# 1955 Corvette: Service Bulletin: Hard Shifting

<b>CHEVROLET—CENTRAL OFFICE</b> DIVISION OF GENERAL MOTORS CORPORATION DETROIT 2, MICHIGAN	
 <b>TECHNICAL SERVICE BULLETIN</b>  Service and Mechanical Department	
<b>SUBJECT:</b> HARD SHIFTING - 1955 MODEL PASSENGER CAR 3-SPEED TRANSMISSION	<b>BULLETIN No.</b> DR #236  <b>SECTION</b> VII
<b>TO:</b> ALL CHEVROLET DEALERS	January 9, 1956
<p>In cases where hard shifting on 1955 Passenger Models with 3-Speed Transmission is experienced in high frequency shifting operations due to malfunction and/or wear of gearshift controls and butting of transmission gears, the condition may be reduced by installation of a Transmission Control Conversion Kit and three new type transmission gears.</p> <p>The new transmission gears which have more tooth chamfer entered production about July 5, 1955.</p> <p>The revised transmission controls entered production beginning with 1956 Model and the Control Conversion Kit has modified parts for use on 1955 Models.</p>

FIGURE I

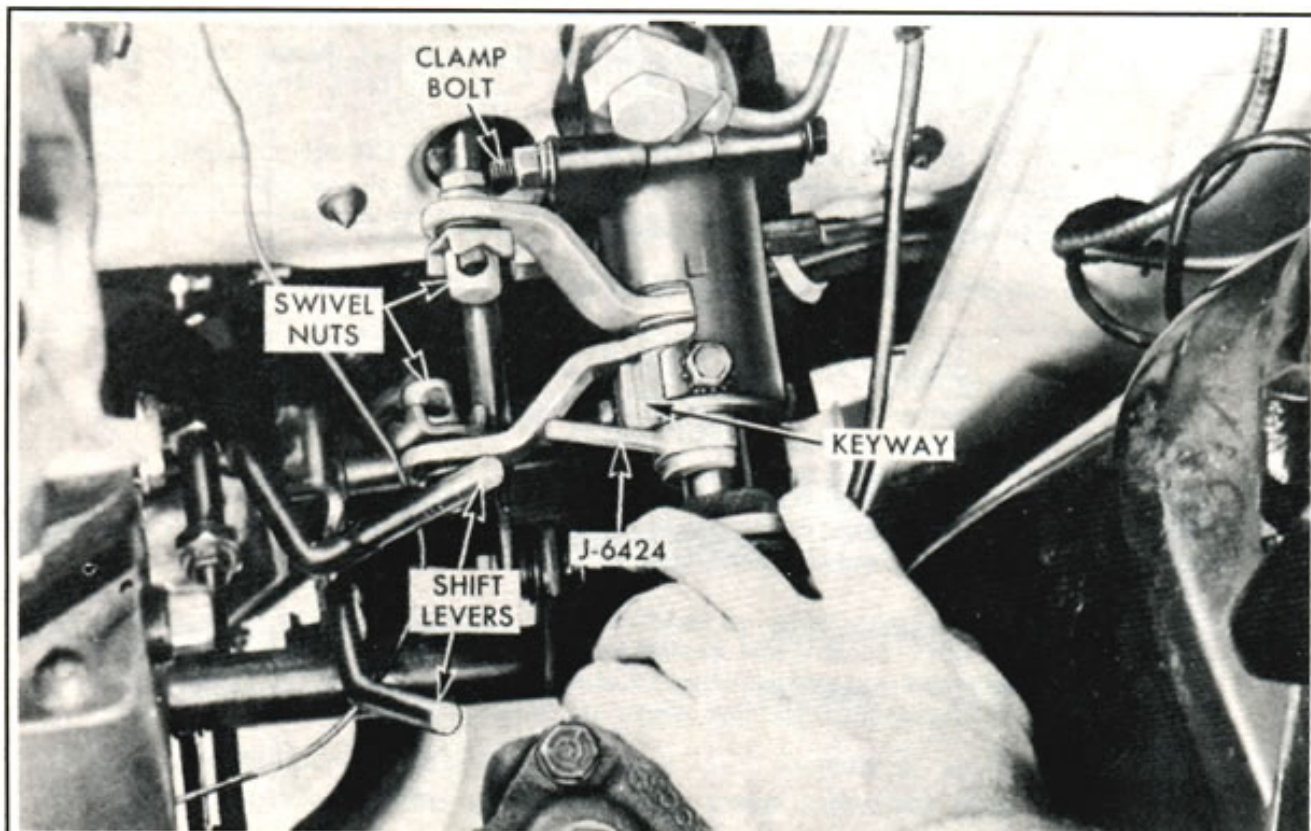
13. Insert gearshift rod ends in swivels - transmission must be in neutral detent in both ranges. Do not tighten.
14. Install alignment gauge J-6424 inserting side stamped "STD" between steering mainshaft and shifter tube in key area. This sets the required 1/16 eccentricity in proper relation to the key on shifter tube. See figure 1.

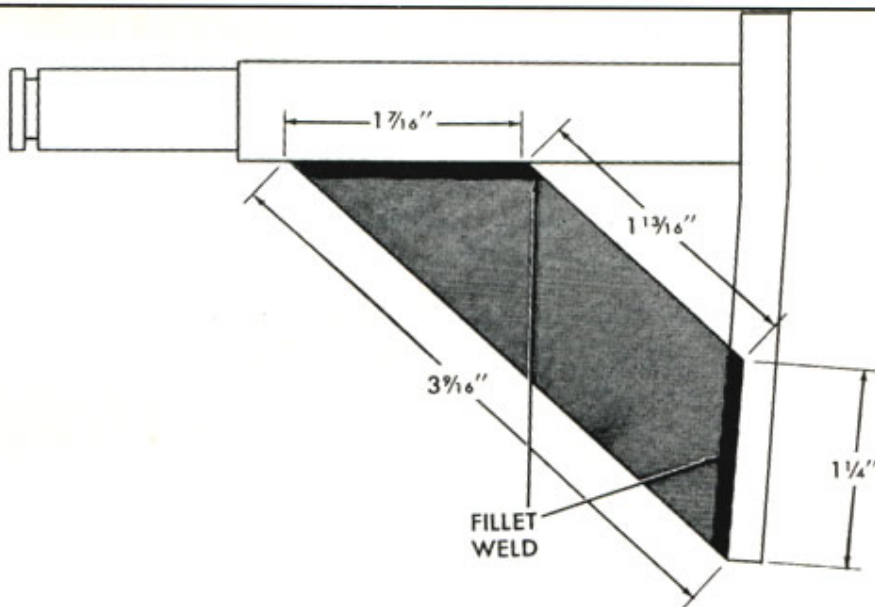
- c. Remove alignment gauge.
16. Make and insert special blade gauge, see figure 2, thru adjusting ring slot, lower levers and gate washer. Tighten swivels on gearshift rods while holding downward lightly on lower levers. Transmission must be in neutral detent at this time.

FIGURE 3

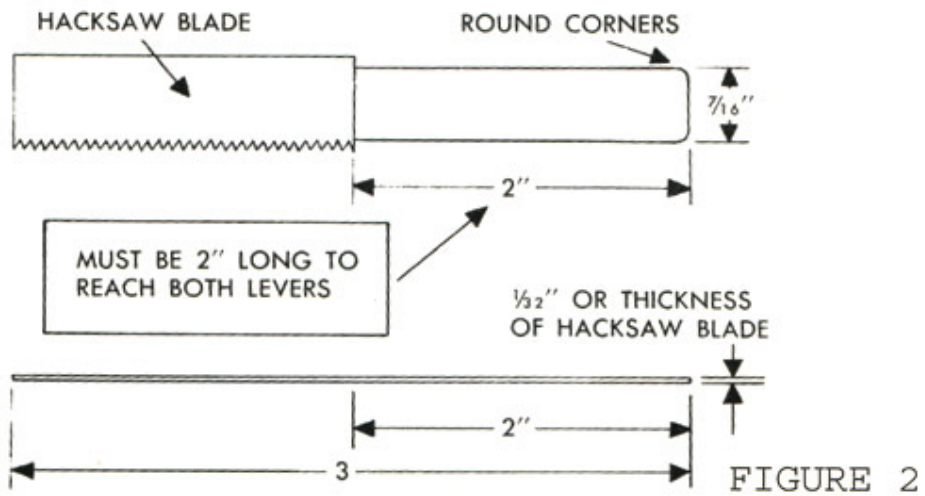
Further improvement of shifting can be made by reinforcement of transmission control rod idler lever support located on left frame rail under toe pan to reduce its deflection. See figure 3.
